**CONESTOGA-ROVERS
& ASSOCIATES**

September 10, 2004

Re: Amendment to Pre-Design Investigations Work Plan
Voluntary Cleanup Investigation
Former GM Fairfax I Plant
Kansas City, Kansas

figure 1.1

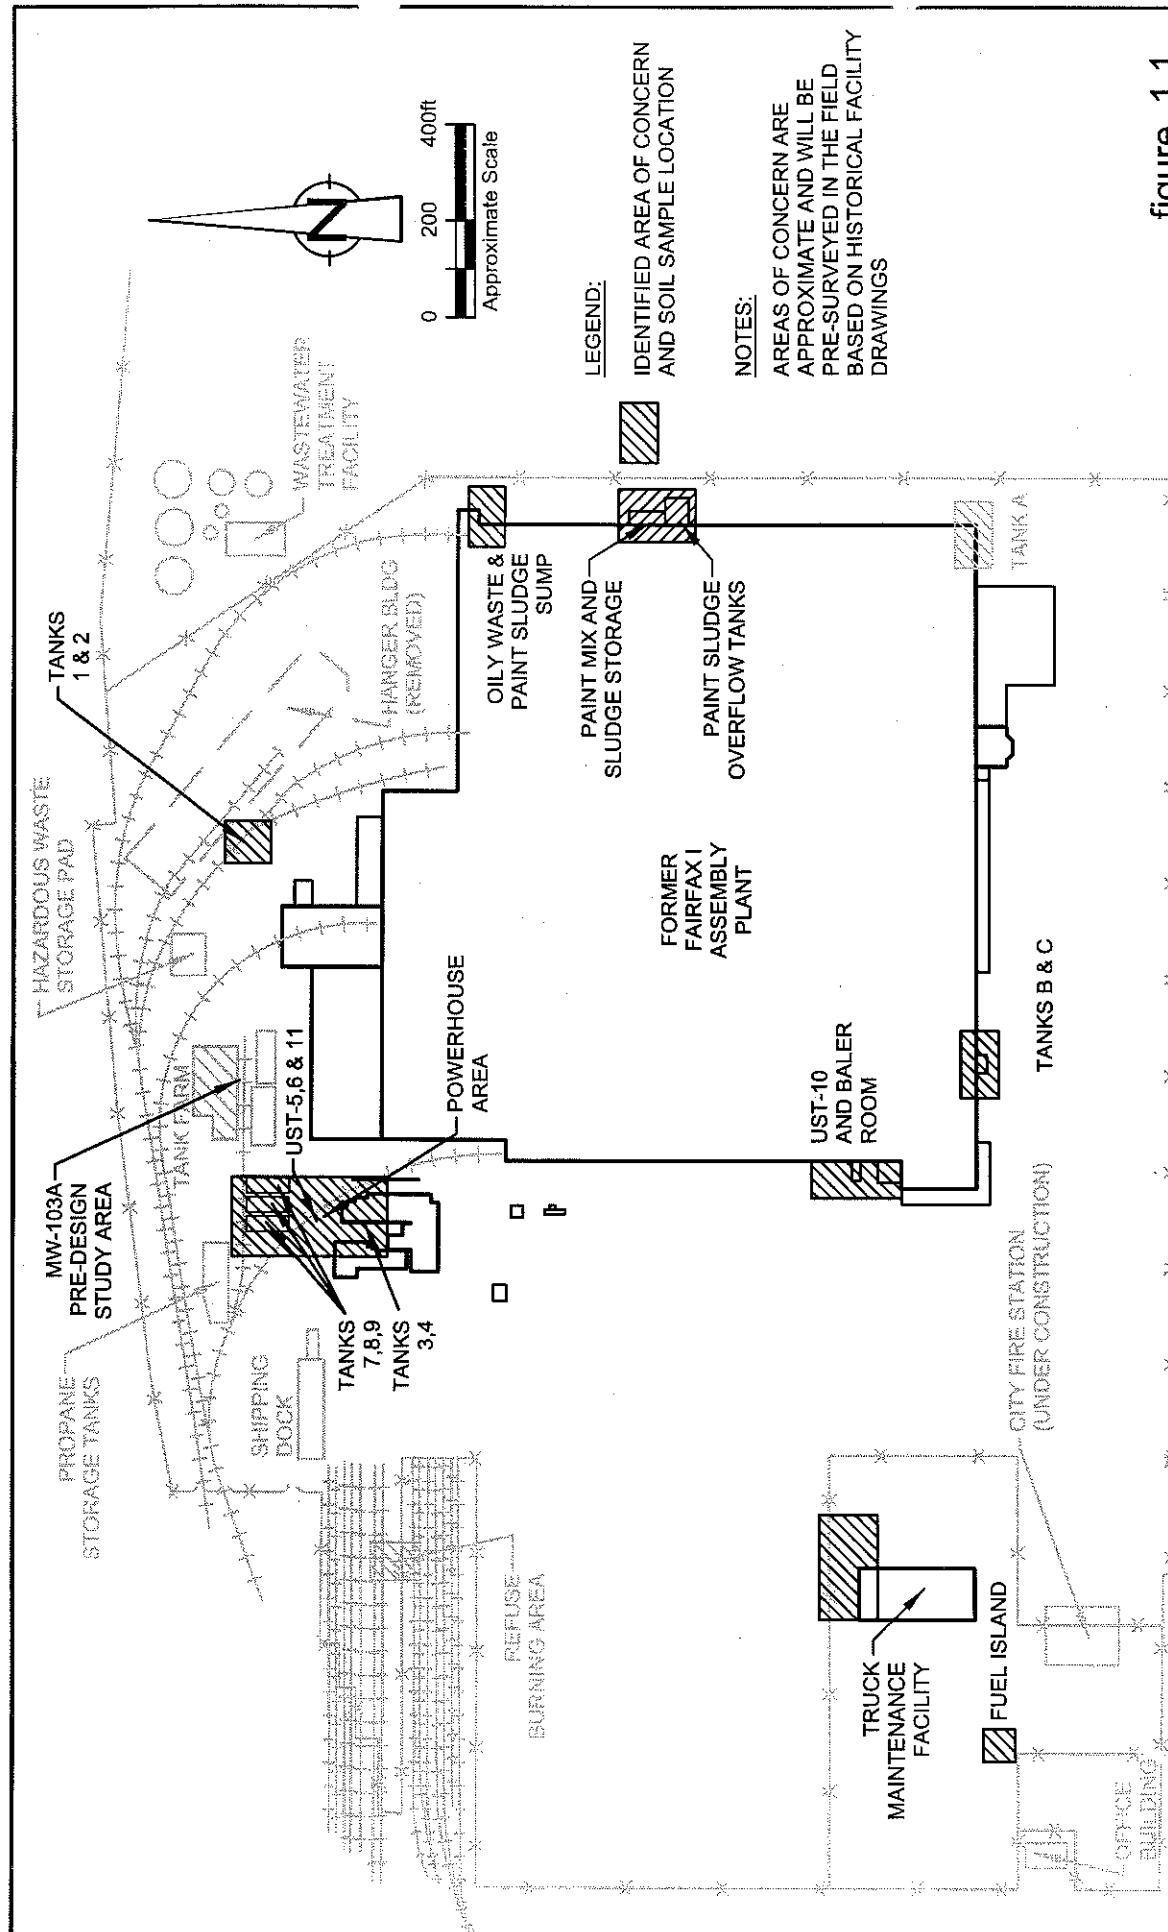
A brief description of the AOCs to be sampled and the rationale for the sampling is provided below. Figure 1.1 presents proposed confirmatory soil sampling locations. Table 1.1 presents a sampling key for the proposed confirmation soil sampling locations. Refer to the July 2000 CRA summary report of the HDR ESA for previous soil and groundwater data mentioned below and for locations of the historical sample locations.

A soil sample will be collected to verify that soil at the approximate depth of the base of the tanks is not impacted at levels above KDHE risk based standards. One soil sample will be collected in the vicinity of USTs 1 and 2 at a depth of approximately 10 to 12 feet below ground surface (ft bgs).

A soil sample will be collected to verify that soil at the approximate depth of the base of the tanks is not impacted at levels above KDHE risk based standards. One soil sample will be collected in the vicinity of USTs B and C at a depth of approximately 10 to 12 ft bgs.

Soil samples will be collected to verify that soil at the approximate depth of the base of the tanks is not impacted at levels above KDHE risk based standards. One soil sample will be collected in the vicinity of the fuel island and one soil sample will be collected in the vicinity of the truck maintenance facility at a depth of approximately 10 to 12 ft bgs.

A soil sample will be collected to verify that soil at the approximate depth of the base of the tank is not impacted at levels above KDHE risk based standards. One soil sample will be collected in the vicinity of UST 10 and the baler room at a depth of approximately 10 to 12 ft bgs.

Soil samples will be collected to verify that soil at the approximate depth of the base of the tanks is not impacted at levels above KDHE risk based standards. One soil sample will be collected in the vicinity of USTs 3 and 4, one soil sample will be collected in the vicinity of USTs 5, 6, and 11, and one soil sample will be collected in the vicinity of USTs 7, 8, and 9 at a depth of approximately 10 to 12 ft bgs.

A soil sample will be collected to verify that soil in the vicinity of the sump has not been impacted at levels above KDHE risk based standards. One soil sample will be collected near the sump at a depth of approximately 4 to 6 ft bgs.

A soil sample will be collected to verify that soil in this area has not been impacted at levels above KDHE risk based standards. One soil sample will be collected at a depth of approximately 4 to 6 ft bgs.

Figure 1.1, enclosed herein, presents the approximate locations of the AOCs and planned soil sample locations. In order to locate these areas and their respective sample points in the field, it will be necessary to pre-survey in historical Site features prior to performing the sample collection. As the Fairfax I Plant has been demolished and the floor slabs and other building

features removed, there is no way that the soil sample locations can be determined in the field. Therefore, based on historical facility drawings, historical surveys, and historical photos, the general locations of the AOCs identified on Figure 1.1 will be staked in the field prior to sampling. Anderson Surveying Company of Lee's Summit, Missouri will be employed to stake these historical site features, as they were previously involved with surveying activities at the Fairfax I Plant when it was operational. Consequently, GM can only make a reasonable attempt to place the confirmatory sample locations near the historical AOCs.
